Seventy-second session Geneva, 20–24 February 2012 Item 3(d) of the provisional agenda Regulations Nos. 13 and 13-H (Braking) - Clarifications

Proposal for Supplement 14 to the 00 series of amendments to Regulation No. 13-H (Brakes of M_1 and N_1 vehicles)

Submitted by the expert from CLEPA and OICA *

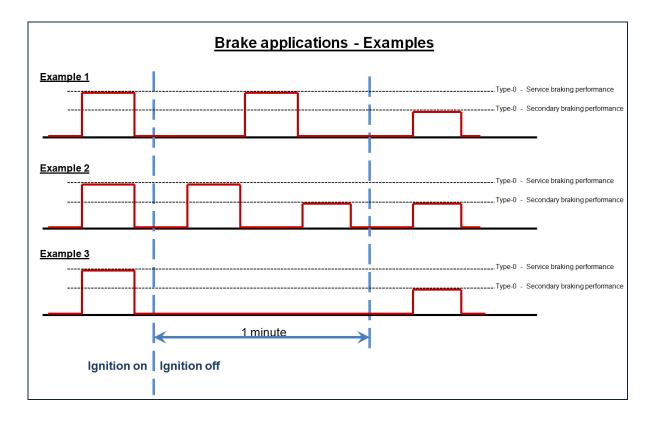
1. The current wording of paragraph 5.2.20.1. may be misinterpreted. This proposal intends to clarify which levels of braking performance are required in the different positions of the ignition key.

2. The practical need of this paragraph was to prescribe a suitable braking performance which would allow a driver, who releases the parking brake of a car parked on a slope, to prevent rollaway even when ignition has been turned off. In such a situation no braking from high speed is indeed required, secondary braking performance is sufficient.

3. After ignition off (i.e. engine stopped), common vacuum booster braking systems can still deliver service braking performance, however for a limited time only, until vacuum or electricity have been depleted.

4. Braking systems with electric control transmission can only produce full service braking performance as long as the system is energized. After ignition off, such systems shut down to avoid the battery depletion.

5. The above proposal considers that secondary braking performance is sufficient to hold the vehicle on a slope. However, similarly to common braking systems, which can still deliver the prescribed service braking performance for a limited time only, i.e. until the

vacuum has been depleted, it is required in this proposal that for at least one minute, the first brake application delivers the prescribed service braking performance. This behavior is therefore similar to that of current "conventional" vehicles with vacuum booster.
